SUPPLEMENTARY ENVIRONMENTAL IMPACT STATEMENT

McARTHUR RIVER MINE PHASE 3 DEVELOPMENT PROJECT

May 2012

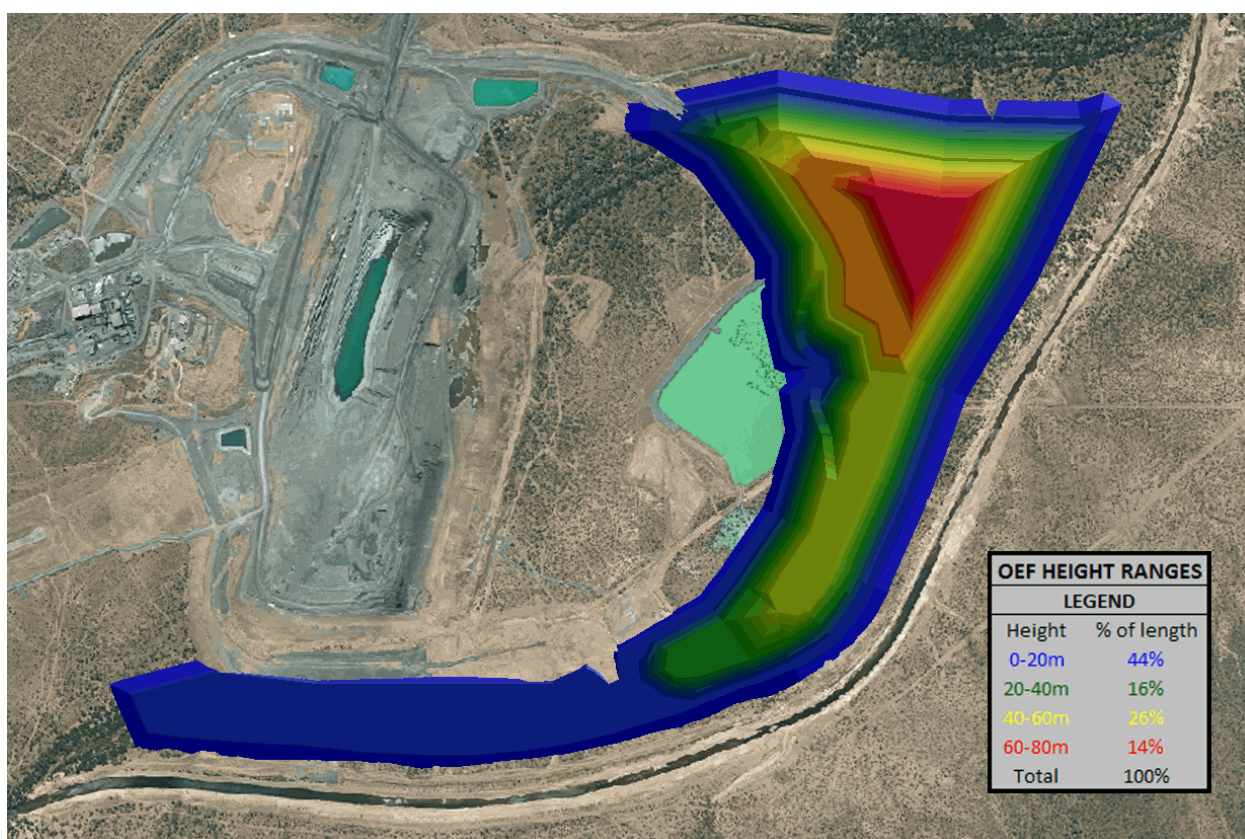
<p>consistent with that objective.</p> <p>Further examination of all possible alternatives to the current OEF configuration should be undertaken with a view to maintaining buffers as wide as possible between waste rock and the river channel.</p>
--	--	--	---

The proposed 75 metre offset of the East and South OEFs from the McArthur River Channel is based on the consideration of many alternative configurations and that presented provides the best combination of riparian zone maintenance, OEF stability and flood protection and reduced footprint. Whilst areas of OEF's could be up to 80m high, the predominant height of the East and South OEFs will be between 0 and 20 metres with batters at a slope of 1:4 (see figure below).

A view of the East and South OEFs is shown in Figure 4-1 of the Draft EIS. These utilise the area between the open pit crest and the Barney Creek and McArthur River Channels, with offsets to allow for crest instability and rehabilitation requirements. The OEFs have a minimum setback of at least 75 m from the crest of the channels, and this buffer is over 125 m in many sections.

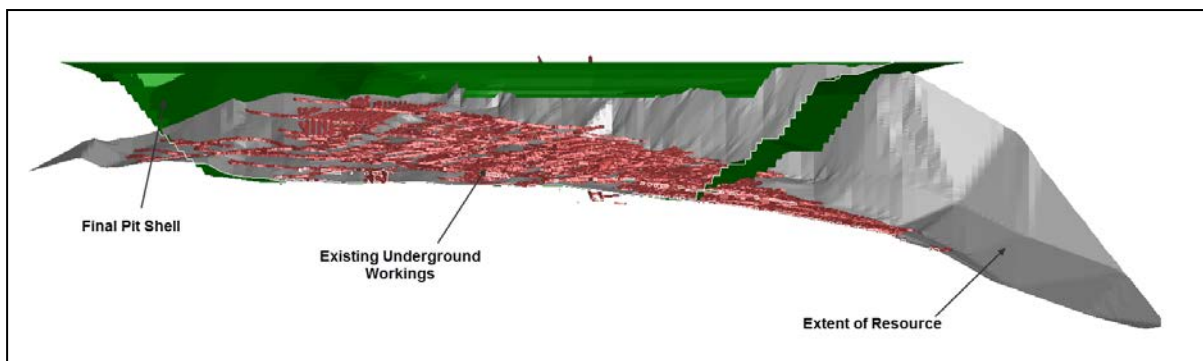
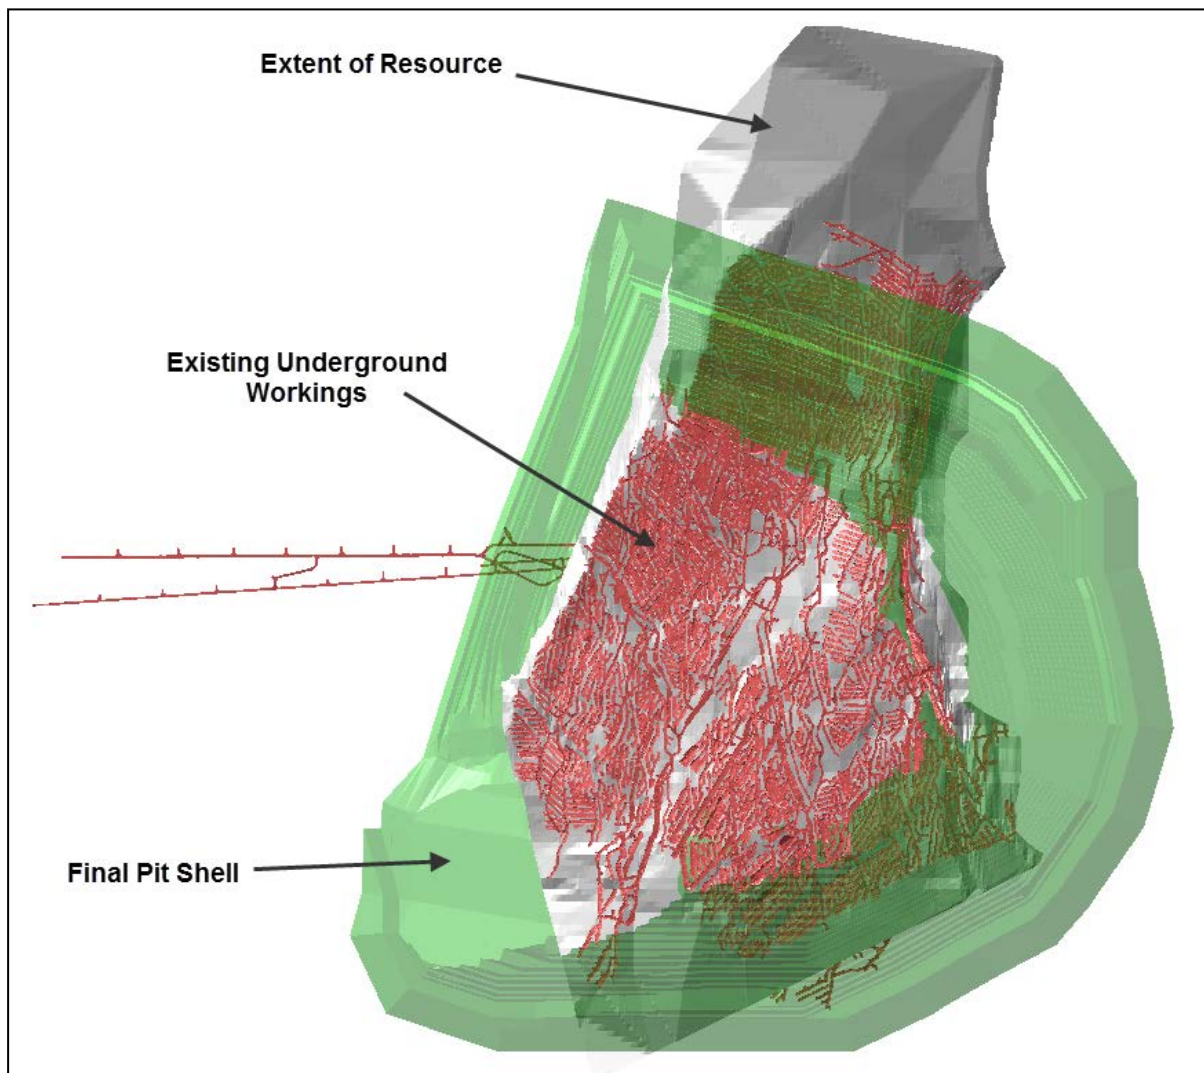
Comment No.	EIS Section	EIS Discipline	Comment
104	S1.1.1; s.3.2.2	Resource and Future Mining	<p>To what extent does the downward sloping ore-body extend further underground than the current proposal aims to remove?</p> <ul style="list-style-type: none"> • Provide a diagrammatic representation indicating the full extent of the known resource, beyond the targeted resource • Does reasonable potential exist for further expansion of the proposed project, such as extension of the pit, or return to underground mining once the pit depth limit has been reached? • If so, how is potential for further future expansion reflected in current proposed designs and environmental management? (Examples might include: avoidance of resource sterilisation; skewed progressive rehabilitation priorities; avoidance of progressive use of pit or underground workings for PAF storage; stalled preparation for closure; etc.)

The figures below provide section and plan views showing the extent of the identified resource, existing underground workings and the proposed final pit.

Note that the resource surface shown is approximate basal surface of the resource. The upper surface of the resource is not shown.

It can be seen that the known resource extends beyond the boundaries of the proposed final pit and the existing underground workings. Optimisation results indicate that there is potential for future resource extraction to the north via open cut methods. Furthermore MRM is aware of another resource block called Woyzbun South which is approximately 150m below (as a result of faulting) the mineralised zone currently targeted by the open pit. Potential to target this via underground methods exists, however no feasibility work has been completed. Both of these potential future options are not sufficiently understood and are subject to future resource optimisation works and mine planning. Furthermore, current commodity prices and mining costs prevent the incorporation of these components into current mine plans.

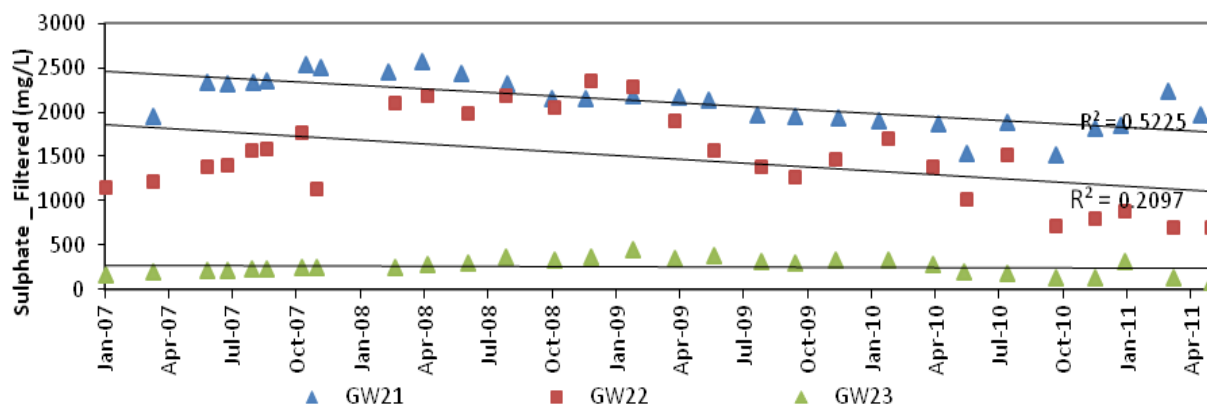
Comment No.	EIS Section	EIS Discipline	Comment
109	App.E1-s.2.1, s.3.7, s3.3.2, s.4.7	Tailings Storage Facility	<p>Seepage volumes</p> <ul style="list-style-type: none"> • Present the following two calculations in terms of total seepage for the entire TSF (in L/day), and from the proposed TSF cell (4). • From App. E1/s. 2.1: <i>the predicted/long-term seepage volumes are generally low and are of the order of 30 to 40 L/day/m width of the TSF wall because of the relatively low permeability of the embankment core, the tailings and the underlying dolomitic siltstone material.</i> • From App. E1/s. 3.7.2: <i>The seepage estimates through the perimeter wall of Cell 2 were estimated in the range of 90 L/day to 170 L/day per metre of wall. With a conservative assumption of seepage from all four walls, daily seepage losses would be in the order of 400 kL to 900 kL.</i> • Appendix E1/33.2 states: <i>Investigation Identified the potential for lead and zinc seepage from the TSF. The report identified fractured geological structure as preferred seepage pathways that have limited the effectiveness of trialled seepage mitigation efforts.</i> <p>Electromagnetic surveys around the TSF have been conducted in 2009 and 2010 to assess seepage occurring from Cell 1.</p> <ul style="list-style-type: none"> • Results and findings of the survey such as aquifer and plume mapping beneath the TSF have not been provided; therefore, an assessment cannot be made on MRM's current environmental performance with respect to groundwater contamination. These should be provided in the Supplement, as a context for the Phase 3 Proposal. • Quantify long term expected transmission rates (from the TSF as a whole/per day) for seepage to escape through the base of the TSF cells to deeper aquifers, bypassing peripheral seepage capture devices (i. e. clay cut-off key, geopolymer barrier, perimeter drain, recovery bores at 10-30m depth).

Four electromagnetic (EM) surveys have been conducted at MRM (annually since 2007 at the end of the dry season) to determine the level of subsurface electrical conductivity surrounding the TSF as a means of detecting subsurface loss of conductive liquids stored in the TSF. This is undertaken by measuring change in measured ground conductivity compared to baseline conditions and complements data retrieved from the groundwater monitoring system.

Results from the 2011 report (Conclusion, Section 5.1) found that changes in ground conductivity (both vertical and horizontal dipole configurations) between 2010 and 2009 have generally shown either no change or increases in ground conductivity, particularly to the north east and south west of the TSF (Lines SW1, SW2, NE1 and SE2). Compared to the 2007 data, ground conductivity has generally remained the same or slightly reduced apart from increases observed on Lines SW1, SW2, NE1 and SE2." EM Surveys will be continued for the Project to determine the potential seepage rates from the TSF. The 2011 report is available in Appendix N.

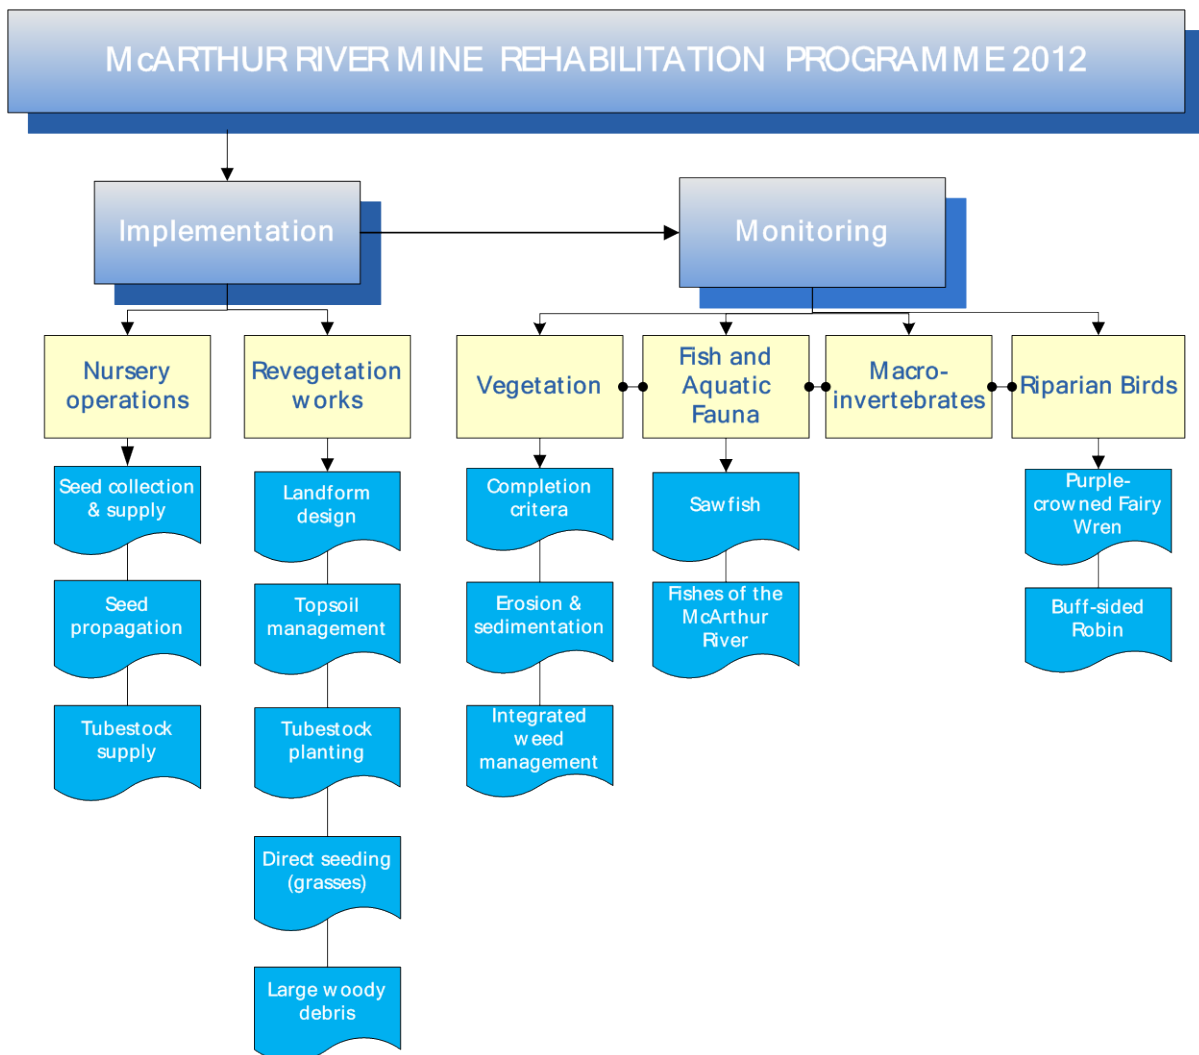
Comment No.	EIS Section	EIS Discipline	Comment
111	s.I3.4.11	Pest Species Management	<p>States:</p> <p><i>More intensive, species-diverse revegetation of the main channel is necessary to create a functioning riparian system along the channel. A pest animal management plan should be implemented to control vertebrate pest animals on and adjacent to the Project site. Included in this plan should be species-specific management and, where practicable, eradication methods for terrestrial vertebrate pest animals on site in accordance with best practice. The plan is envisaged to include horses, pigs, donkeys, and unmanaged cattle.</i></p> <p>The language used in the Draft Environmental Impact Statement (DEIS) suggests the pest animal management plan is not in place or committed to yet. NRETAS supports commitment to the plan, along with increased measures to maintain cattle-exclusion fencing, control weeds and accelerate the establishment of functional riparian corridors on both sides of the river.</p>

The fence aims to prevent access to the area by pest animals that have a negative impact on the success of the rehabilitation. Prior to the completion of the fencing, mustering was carried to remove all stock from inside the fence.

During the wet season, fences across the river and tributaries will be damaged by flood water and hence are replaced when flow has reduced. Additional mustering will be conducted following the wet season to ensure the rehabilitation areas are protected during the dry season.
